METROPOLITAN GOVERNMENT OF NASHVILLE AND DAVIDSON COUNTY

STAFF RECOMMENDATION
1717 Woodland Street
April 16, 2014

Application: New construction—addition
District: Lockeland Springs-East End Neighborhood Conservation Zoning Overlay
Council District: 06
Map and Parcel Number: 08310030700
Applicant: Derek, Cathedral Homes
Project Lead: Melissa Baldock, melissa.baldock@nashville.gov

Figures 2 & 3 show the section of the west elevation which will be expanded with an addition

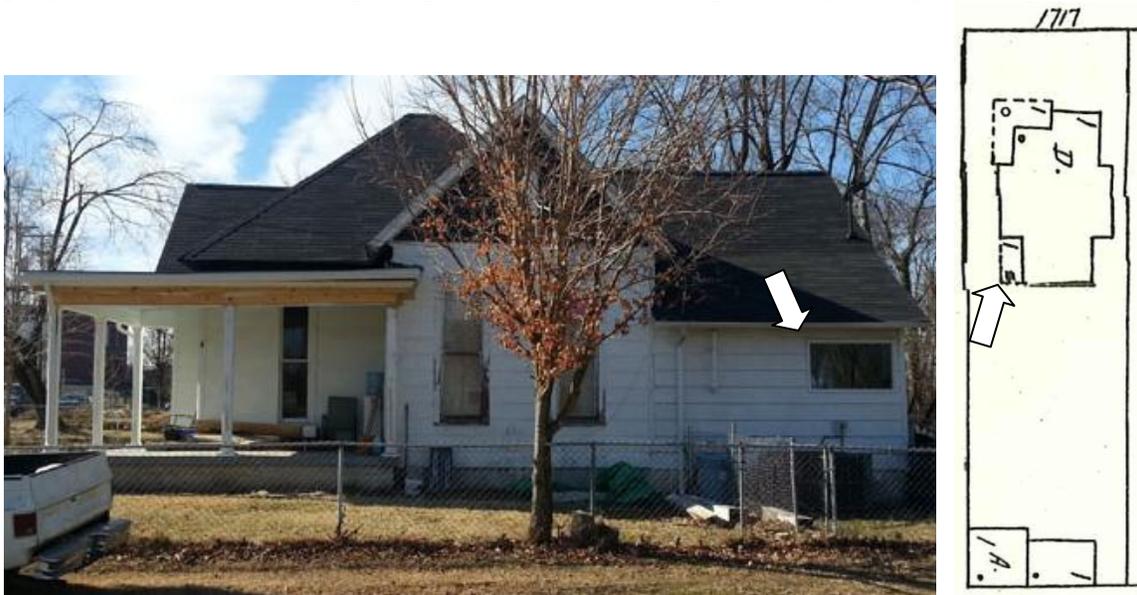
Height & Scale: The proposed addition will be no taller and no wider than the historic structure. The majority of the addition will be located behind the historic house. However, the applicant is proposing to build off the west side of the house, behind the gabled bay (Figures 2 & 3). The applicant is proposing to add to this west elevation a section that is five feet, six inches (5'6") wide and eighteen feet, seventeen inches (18'17") deep. Staff finds this addition to the west façade to be appropriate for several reasons. This portion of the house is not easily visible from the street, and adding on to it will not significantly impact the historic character of the house. Also, the addition will still be inset one foot (1') from the protruding bay, which will help differentiate it.

Figures 4 & 5. The window indicated with the arrow will be removed and new window openings installed on this façade. The 1957 Sanborn maps shows that this portion of the house was formerly a porch that was later enclosed.

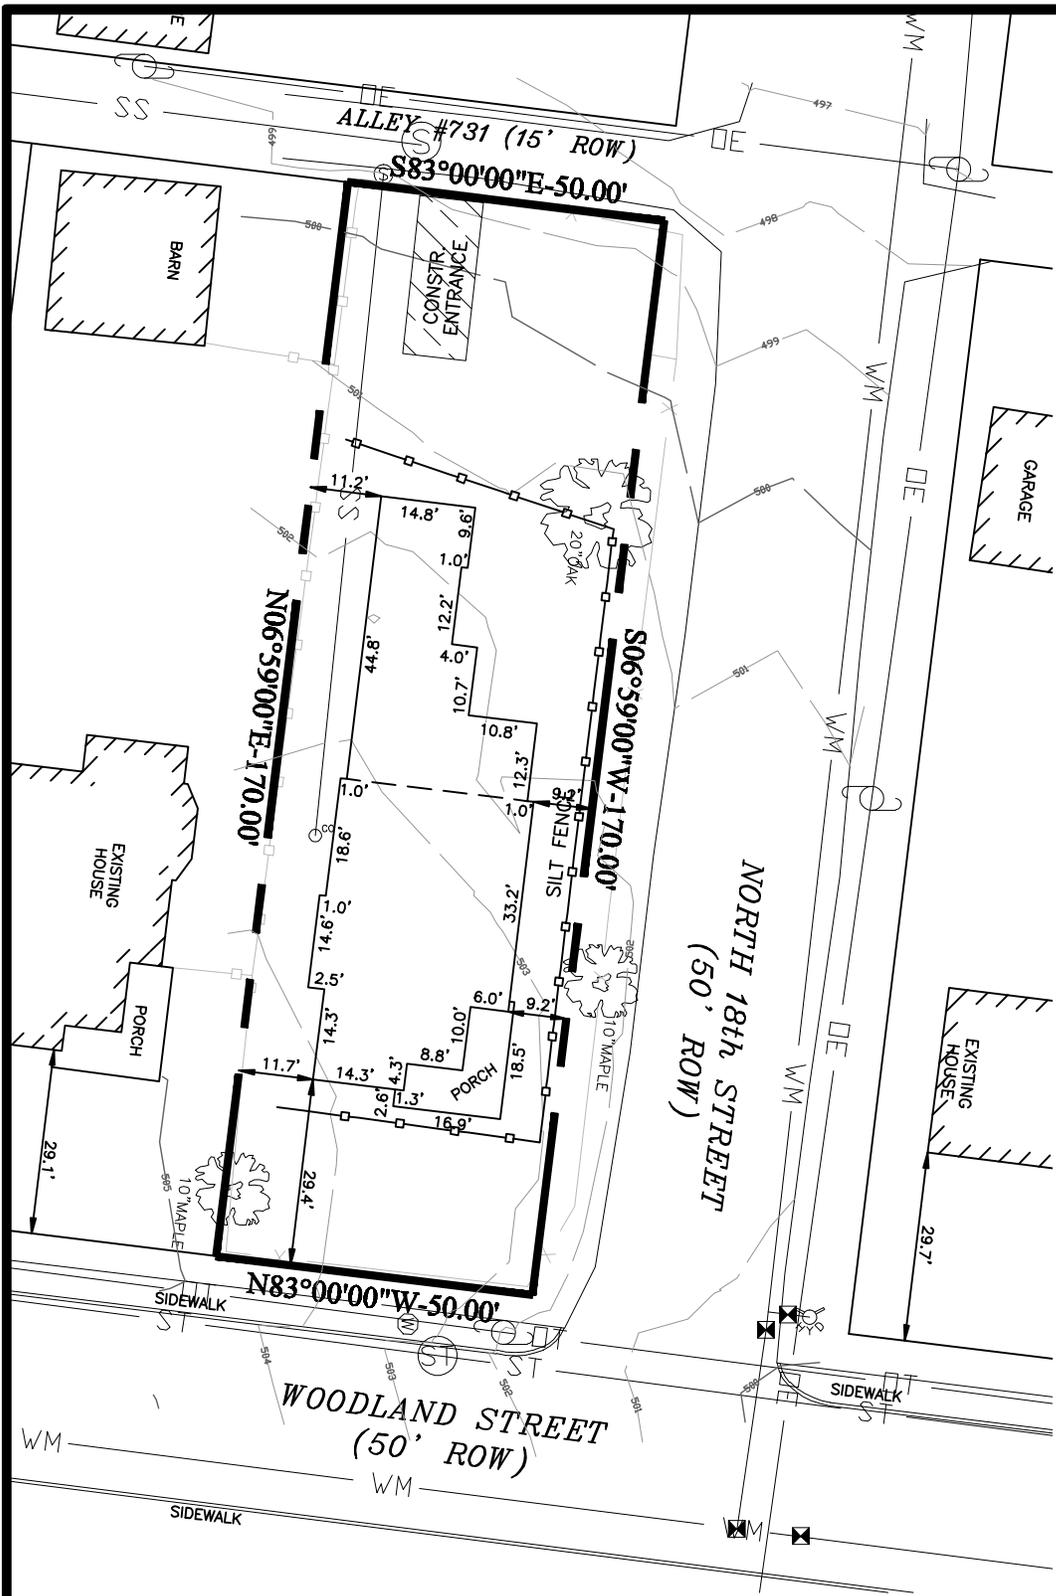
Proportion and Rhythm of Openings: The applicant proposes to restore most of the original wood windows on the historic house. On the North 18th Street/east façade, the applicant is proposing to alter the window openings on the portion of the house behind the projecting gabled bay (Figure 4). The 1957 Sanborn map shows that this portion of the addition was formerly an enclosed porch, so the existing window pattern is not historic, and the proposed new window openings are more in keeping with typical proportion and rhythm of openings for a house of this age and style (Figure 5).

1. Staff approve the foundation material, window and door specifications, and asphalt shingle color prior to purchase and installation;
2. The HVAC and other utilities be placed at the rear, or on the west façade beyond the midpoint of the house.
